Alyson Meadows Subdivision Preliminary Plat SD2021-0039

FINDINGS, CONCLUSIONS LAW, AND ORDER

Comment black text below by Mr. Jone Canning, PE/PLS, Centurion Engineers, Inc.

***Comment Actions by Elwin T. Butler, PE, Matrix Engineering, Inc. (red text)**

DATE
01/26/2024
SHEET
PP100

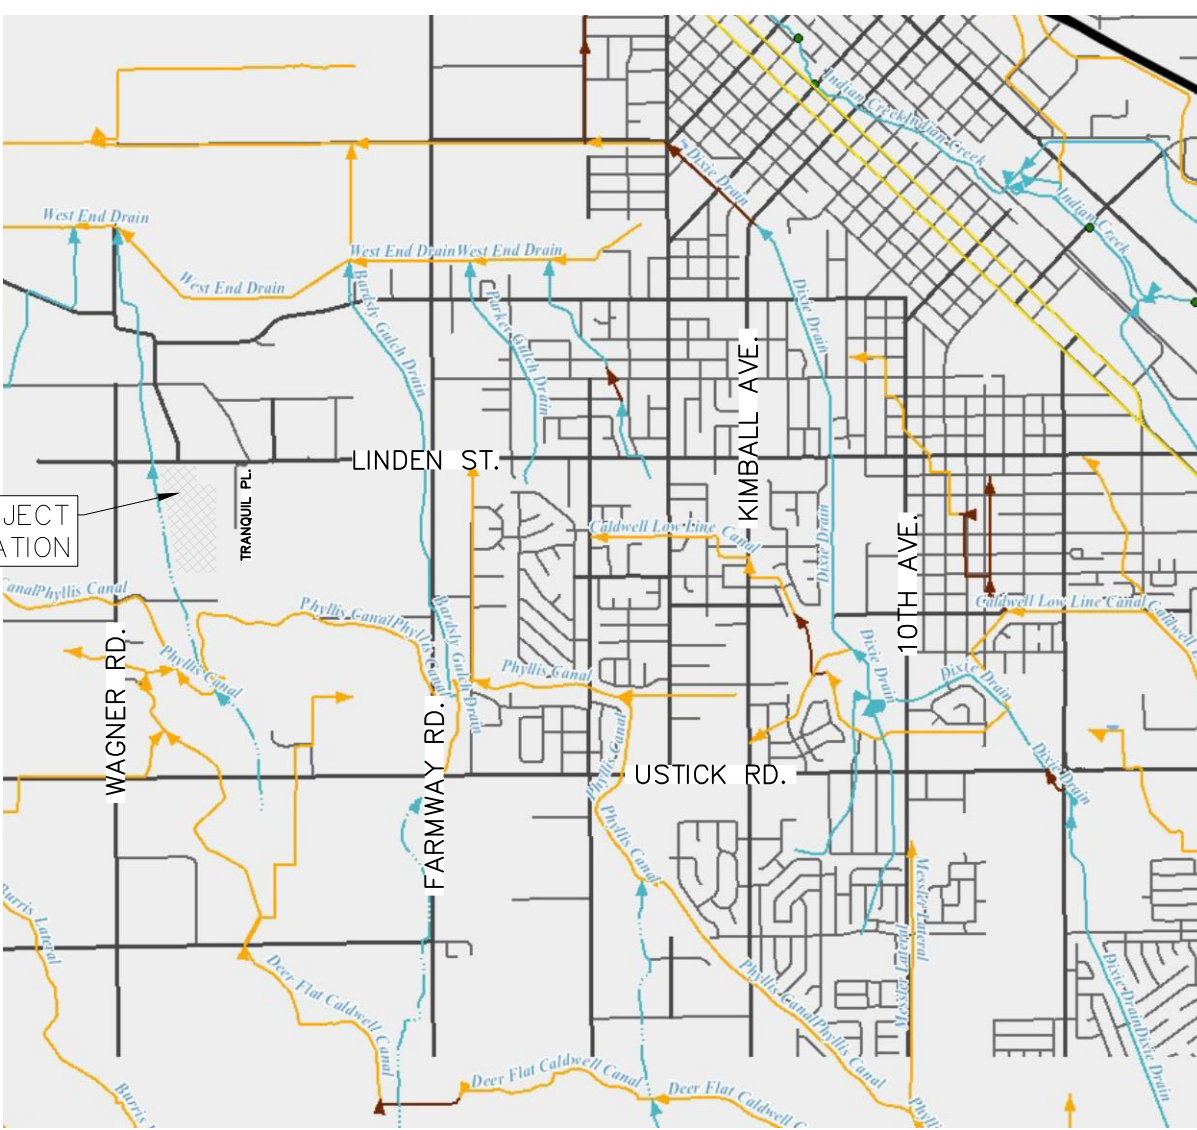
9A. New Comment: Preliminary plat note 1 uses the word “including” for the easements along the private road. We would suggest that could be inferred to mean the internal roads are public. We suggest the word be changed to “and”. **Added an “and” in place of “including”. However, edited entire note to define easements.**

9B. New Comment: Preliminary plat note 2 identifies side lot easements. Please advise on where the terminate at the rear lot lines. Do they continue across the Cooper Drain to the west and the drainage and irrigation easement to the east? **Revised line work and edited note easement text providing definition to easement priority. Cooper Drain (“now “D” Drain) easement, cannot be encroached upon.**

9C. New Comment: Preliminary plat note 3 refers to the Cooper Drain. Please be sure to provide the beneficiary of the easement as the Pioneer Irrigation District when the final plat is prepared. **Added Pioneer Irrigation District as beneficiary and changed name per District’s request to “D” Drain.**

9D. New Comment: Preliminary plat, Note 4 calls out an “irrigation” easement. The text in Lots 7 and 8 also calls out “drainage”. Does the plat note need to be revised? **Changed to standard 10-foot utility and fence**

- 9E. New Comment: Regarding preliminary plat note 4, who is the beneficiary of the easement? **Plat Note 4 has been removed. Boundary easements are traditional utility and fence easements as described in Note 2.**

- 9F. New Comment: The easement on the north boundary of Lot 3 is not identified as to its purpose. Is it a continuation of the easement along the lot's east boundary? What is the width of this easement? Is it intended to connect to the side lot easement on the north side of the lot extending from the road? What are its terminus points? **The purpose of easement, width and terminus points have been clearly addressed on plat.**

- 9G. New Comment: The easement on the south boundary of Lot 13 is 20 feet wide but is not identified as to its purpose. It is a continuation of the easement along the lot's west boundary. It intersects the Cooper Drain easement. Should the Cooper Drain easement be extended to the south boundary of the subdivision? And then where would the 20-foot-wide easement terminate? **This easement has been changed to 10 feet and is defined in Note 2, Boundary easements. The Cooper drain easement has been extended to the parcel boundaries. Agencies, Lot Owners, and Utilities are required to obtain a permit to encroach upon the Cooper Drain easement.**

- 9H. New Comment: The easement along the north boundary of Lot 11 intersects the access easement accessing Lot 12. The use of the two easements is not the same. Does the drainage and irrigation easement extend across Lot 11 or terminate at the west boundary of the access easement? **See Note 2 for Boundary lot line easement definition. Lot 12 is defined the same as defined in the Rhetts Acres approved final plat.**

- 9J. New Comment: As the internal roads are private, please add "Canyon County" to plat note 7. Canyon County will now also be reviewing the road drainage. **Canyon County added to Note.**

- 9L. New Comment: There are easements shown on Lots 1 and 21 that are common lots. What are the easements for? Who is the beneficiary? Are they necessary? Could they be blanket easements? **These are typical utility easements required along public roads. A beneficiary has been provided.**

- 9M. New Comment: There are 10-foot-wide easements shown on the north side of Lots 2 and 20. What are the easements for? Who is the beneficiary? **These are typical interior lot line easements. Lines have been corrected to 5 feet wide as they are interior lot line easements. See Note 2.**

- 9N. New Comment: There is an easement along the east side of Lot 2. What is the easement for? Who is the beneficiary? What is the width? **This is a typical boundary lot line 10 feet wide easement. See Note 2.**

SHEET
PP101

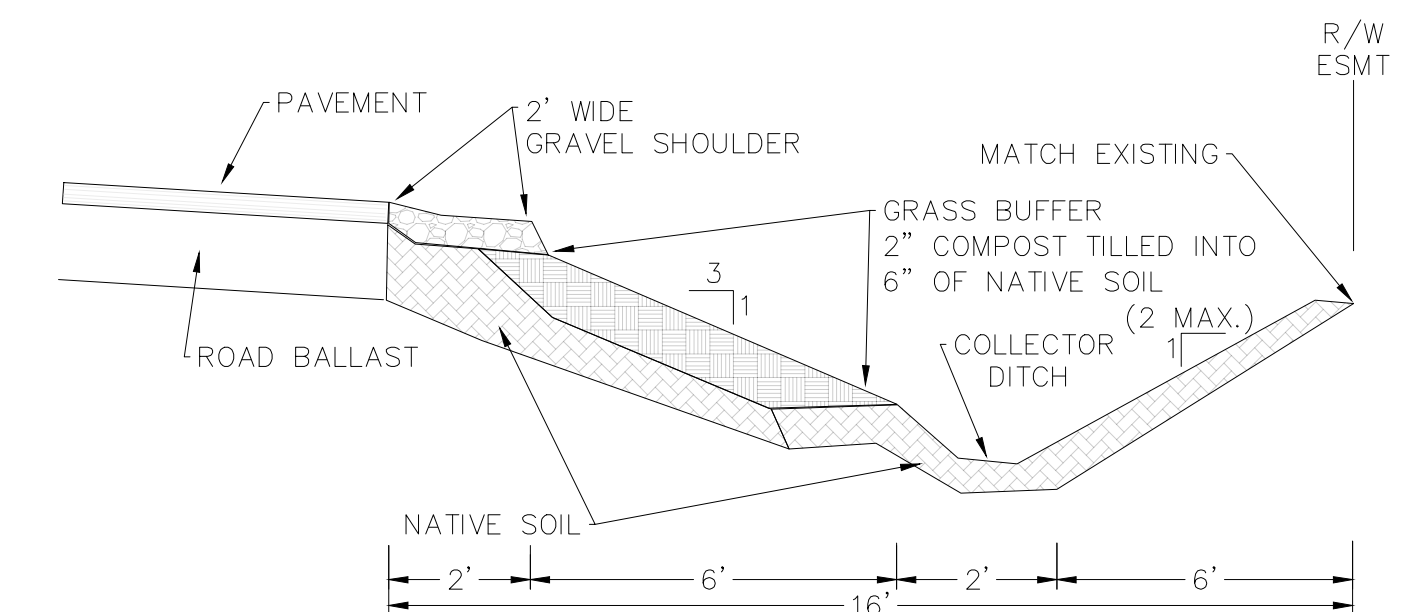
11. We note specific locations on sheet PP101 for wells and septic drainfields. Have these locations been shown based upon field testholes? **Based upon the comment response, is an approval from the Southwest District Health available? No, reports and approvals are in progress. These are 1st steps toward completing this process.**
